CAMBRIA SUBSTATION: ADDENDUM SPECIFICATIONS

DR: ASK	ENG: ASK	CH: ASK
WO#: 1 RIVERSIDE PLAZA COLUMBUS, OH 43215	APPD: ASK	DATE: 10/24/2019
DWG. NO. E-1		R 2

APPALACHIAN POWER CO.  
**CAMBRIA SUBSTATION**

**SITE PLAN**  
SITE AND GRADING PLAN

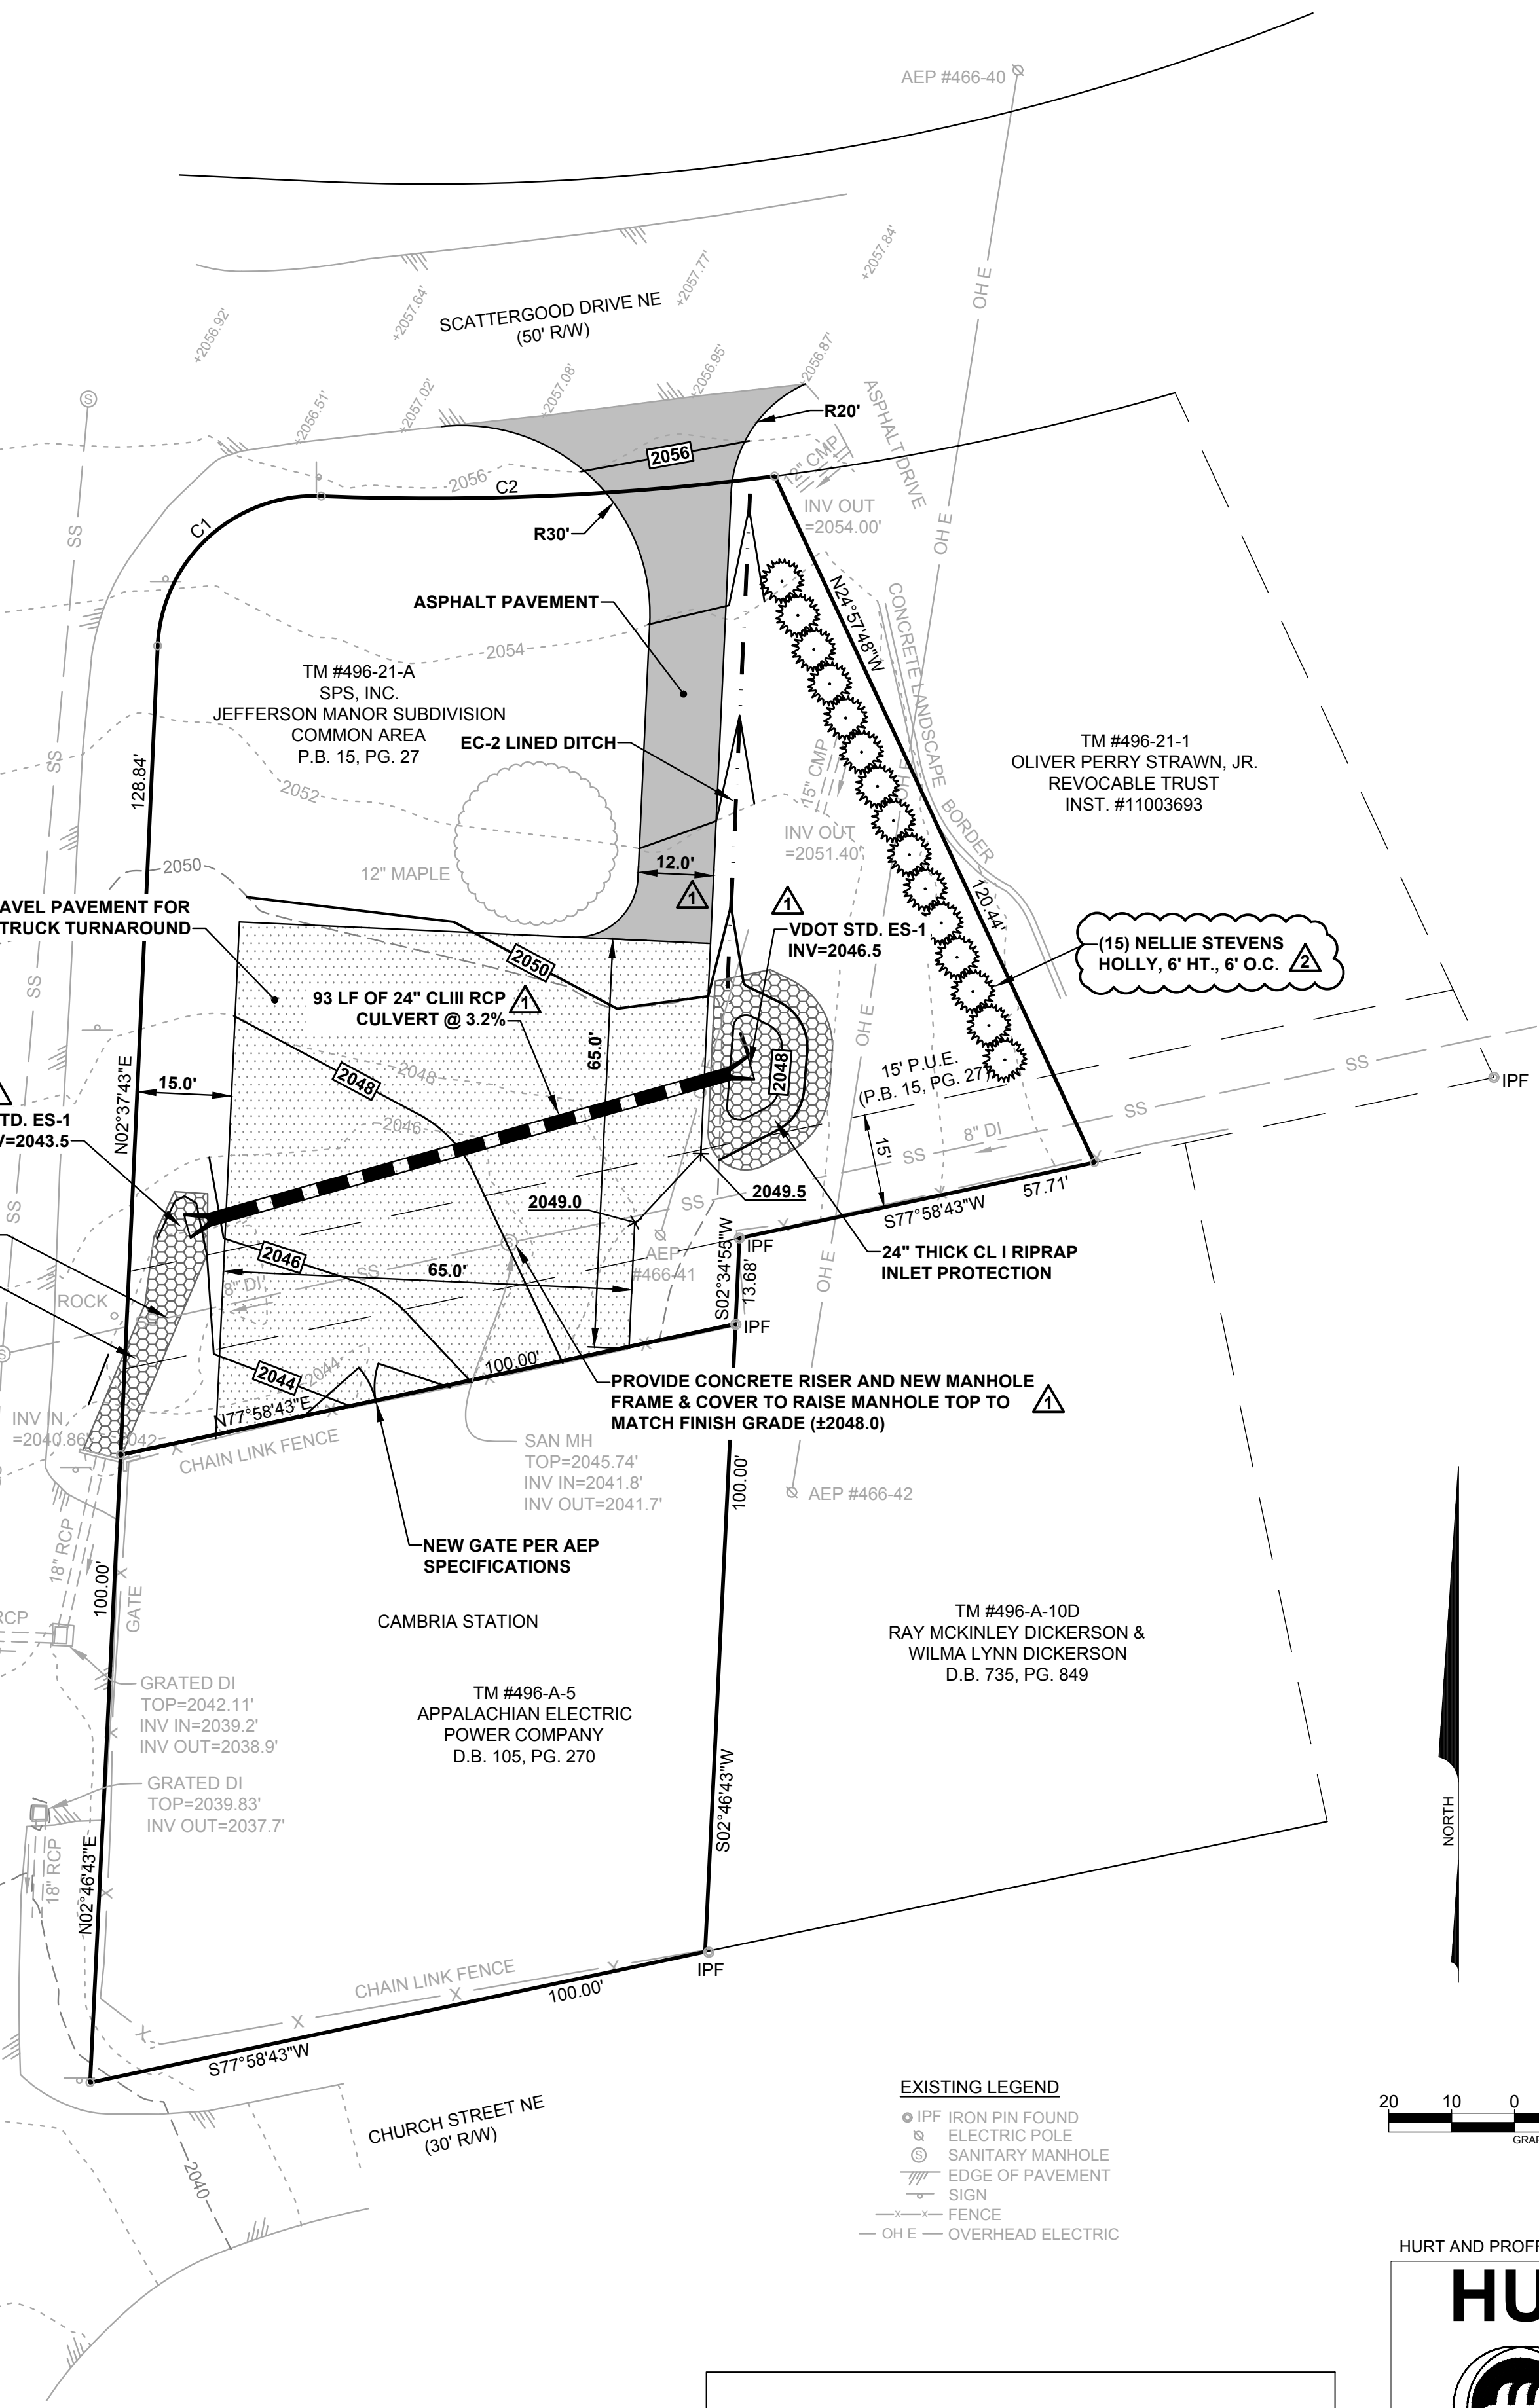
1	8/25/2020	PER TOWN COMMENTS
2	9/7/2021	REMOVE STAGING AREA FENCING
